Addendum 1 for RFB927940-04

Project Name: WRC Decentralization Phase 4 & Fire Alarm Phase 3 (9279.40 & 9279.41) Bid Issuance #4
DAS RFB #: 927940-04
DAS Project #: 9279.40 & 9279.41
Date: 5/21/2026

CHANGES TO DRAWINGS

09-M201

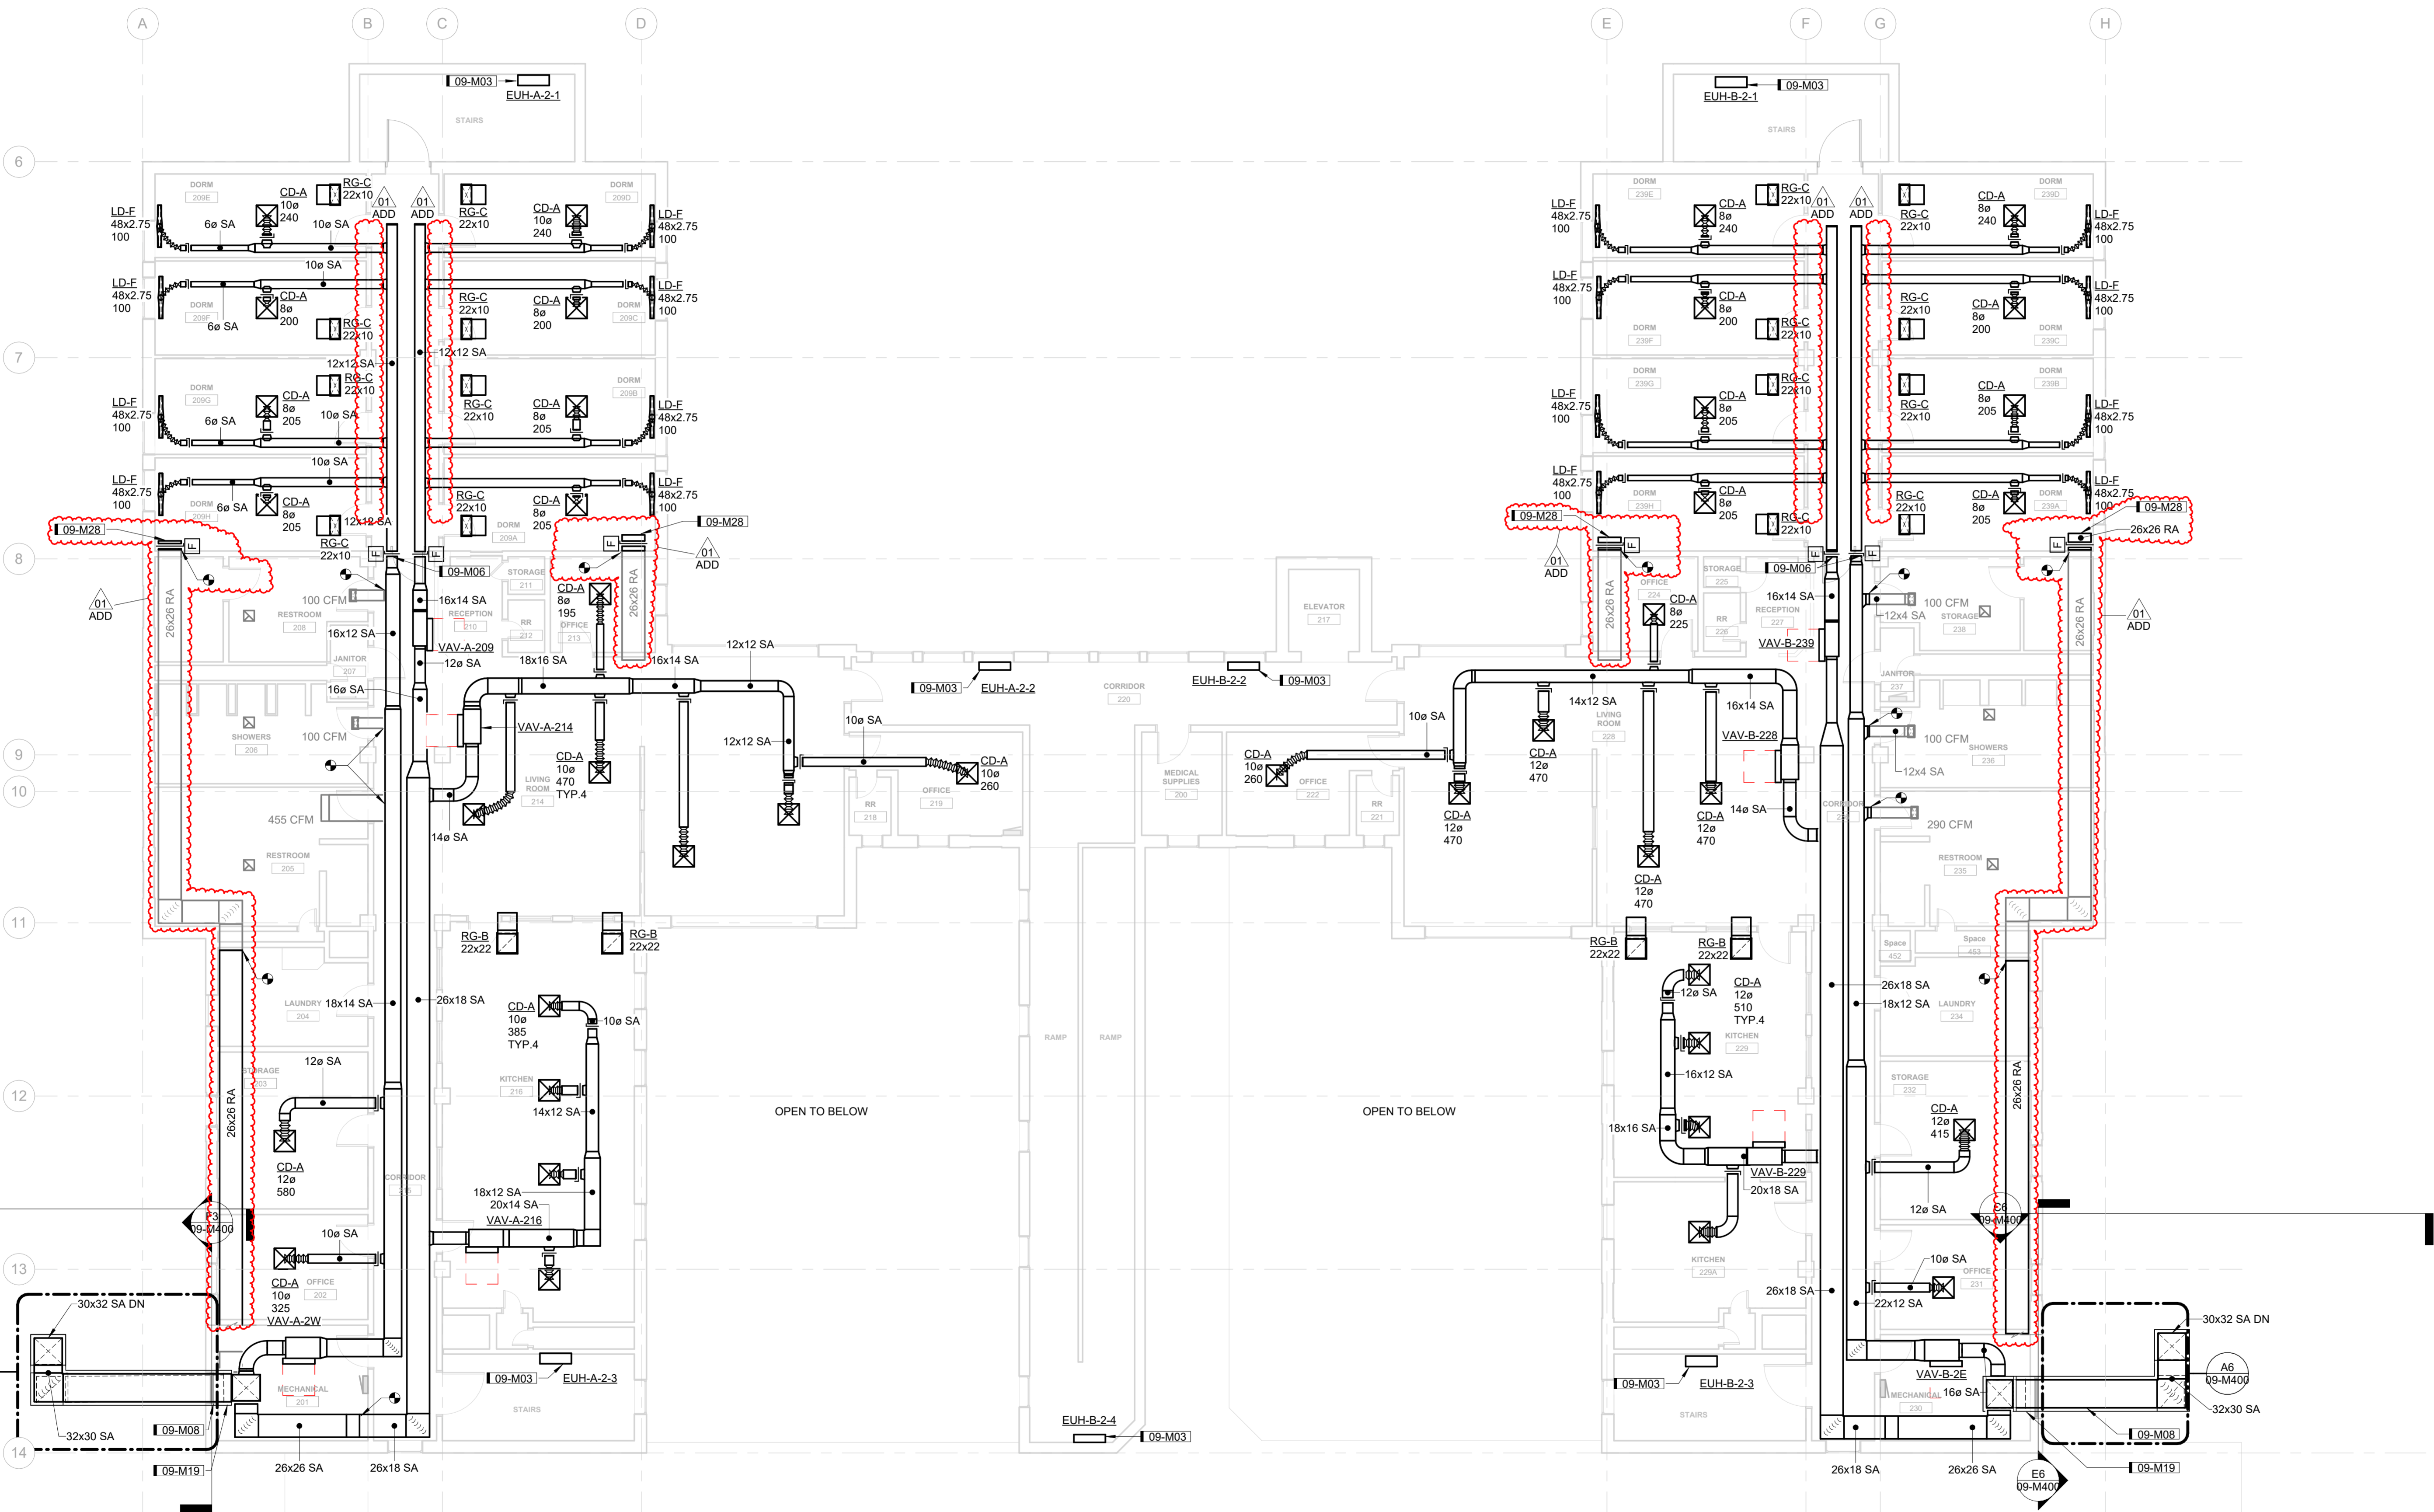
- **REVISE** supply ductwork in area B.
- **09-M201 – FIRST FLOOR MECHANICAL PLAN:**
 - **REMOVE** fire dampers between corridor and individual dorm walls.

- **ADD** return ductwork and fire dampers.
 - **ADD** Keynote 09-M28.
- **09-M202 – SECOND FLOOR MECHANICAL PLAN:**
 - **REMOVE** fire dampers between corridor and individual dorm walls.

09-M202

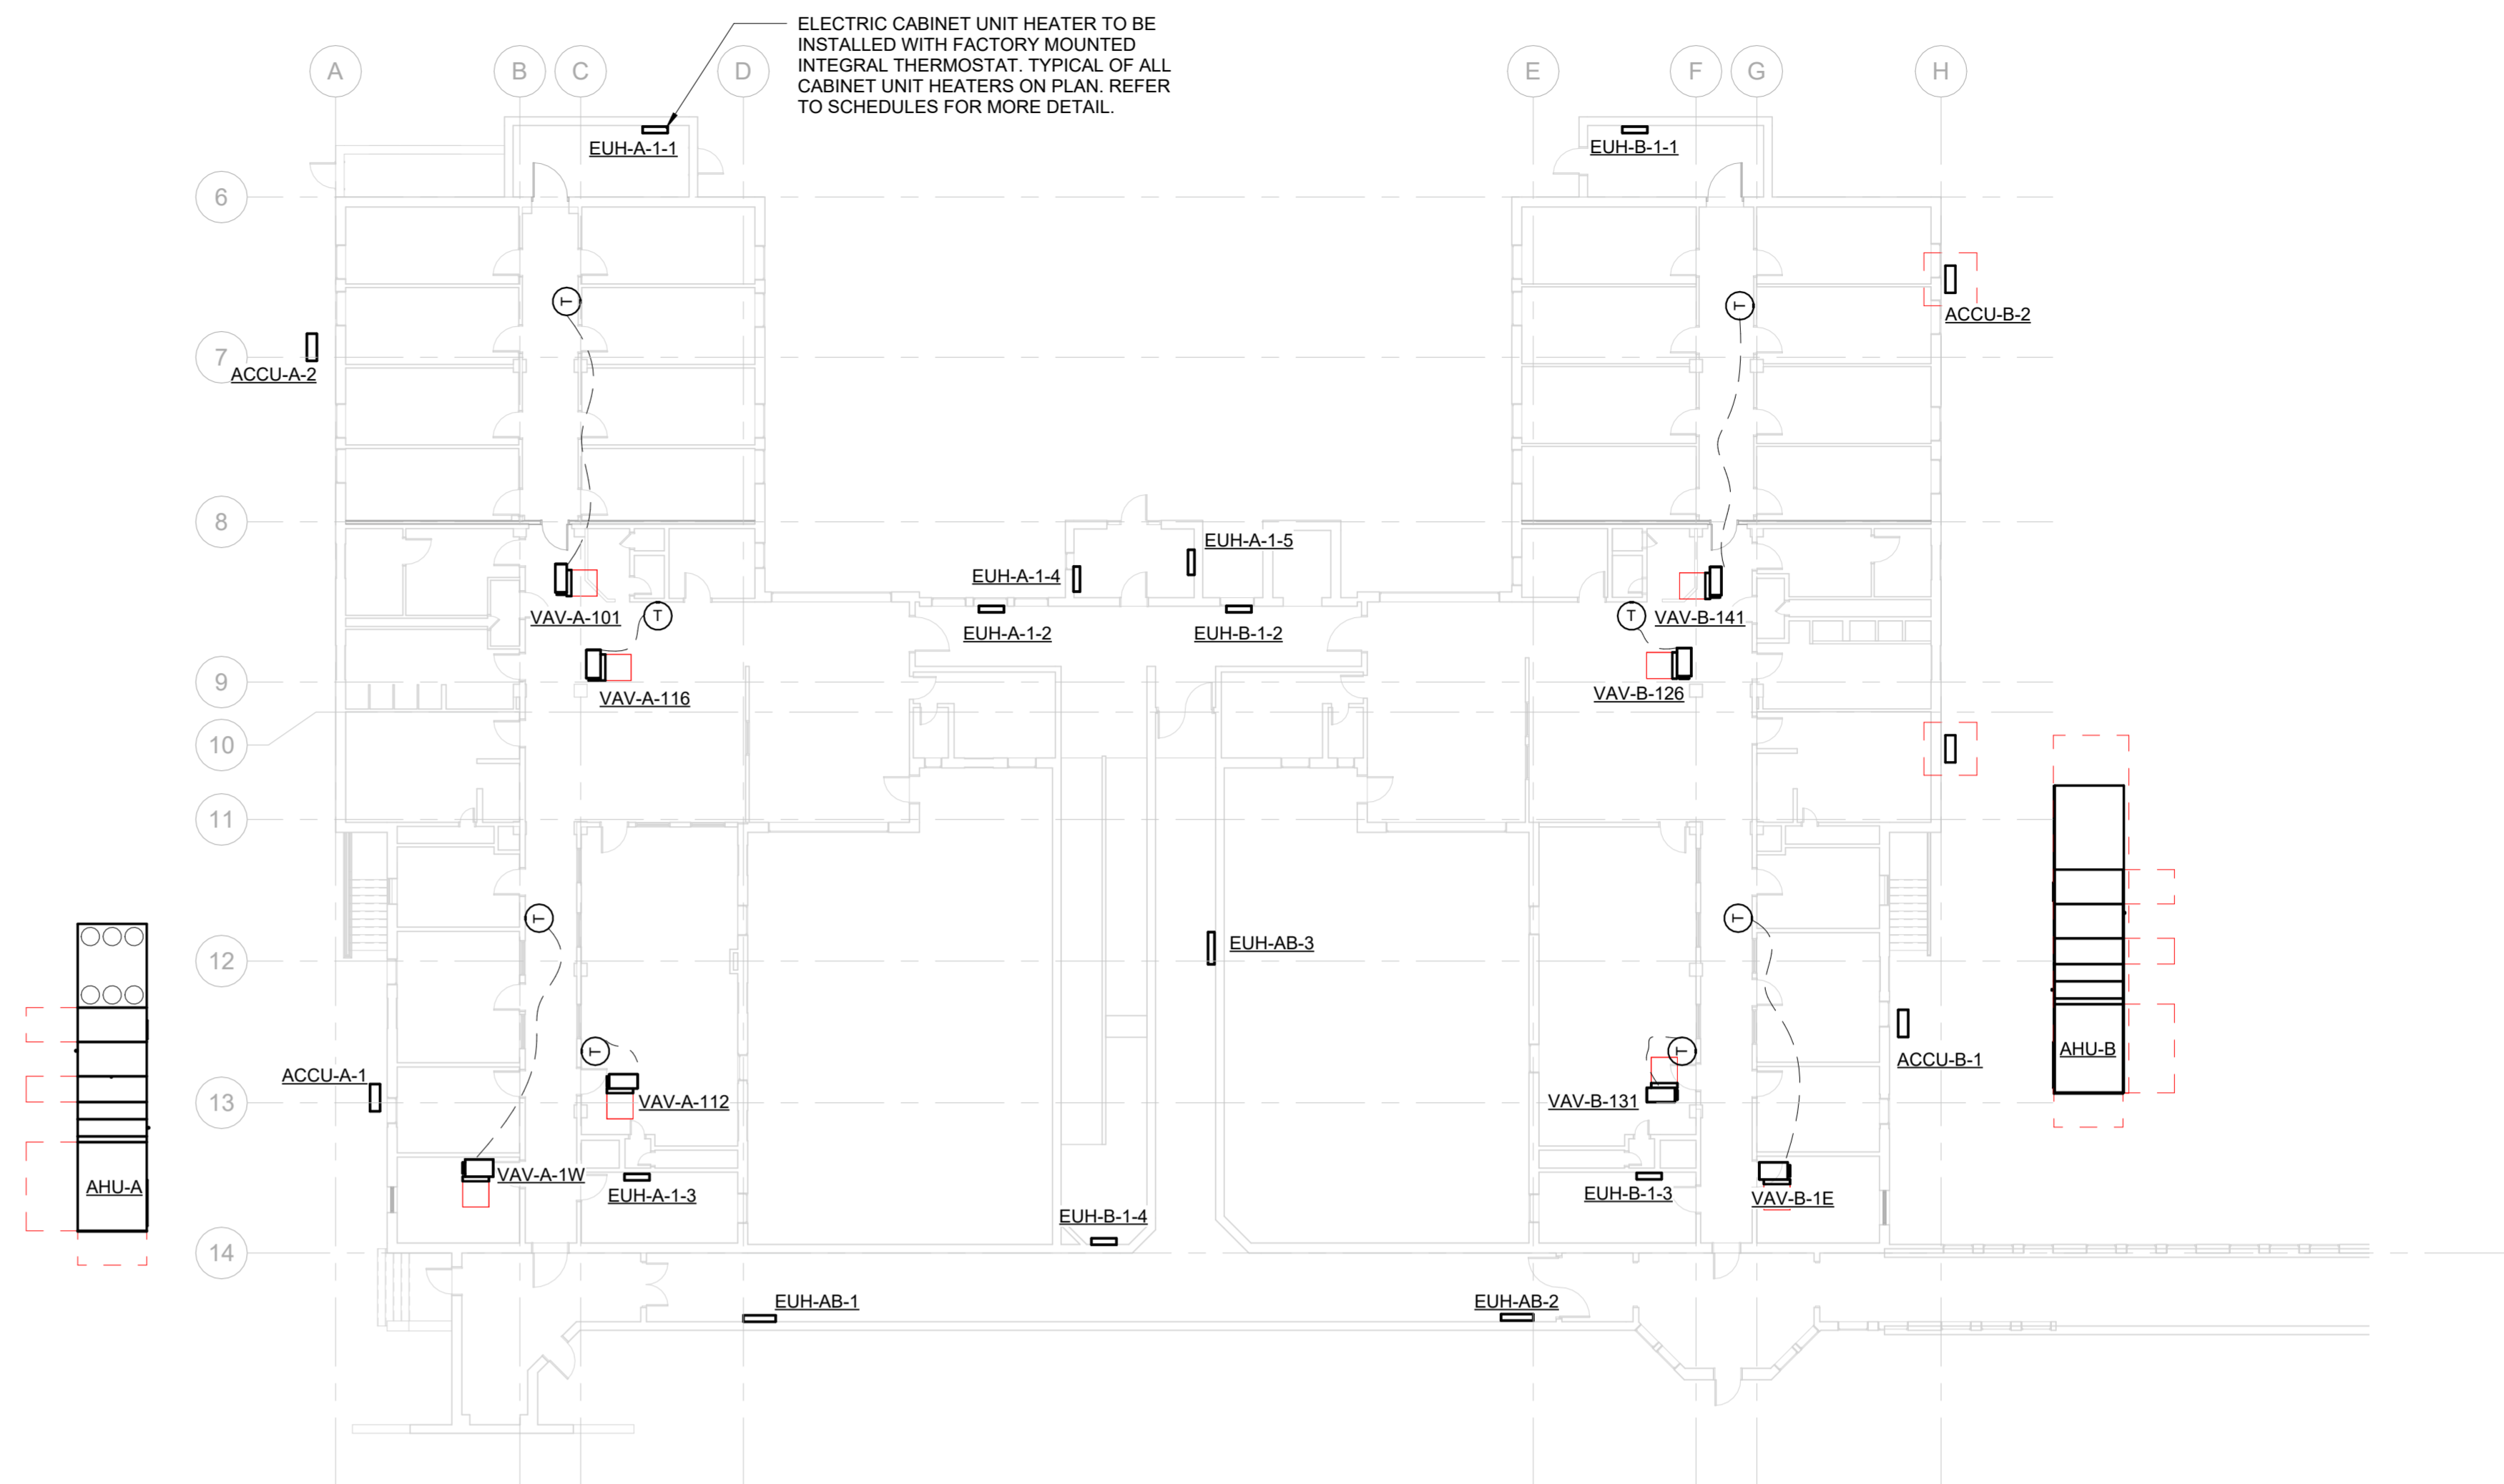
- **ADD** return ductwork and fire dampers.
 - **ADD** Keynote 09-M28
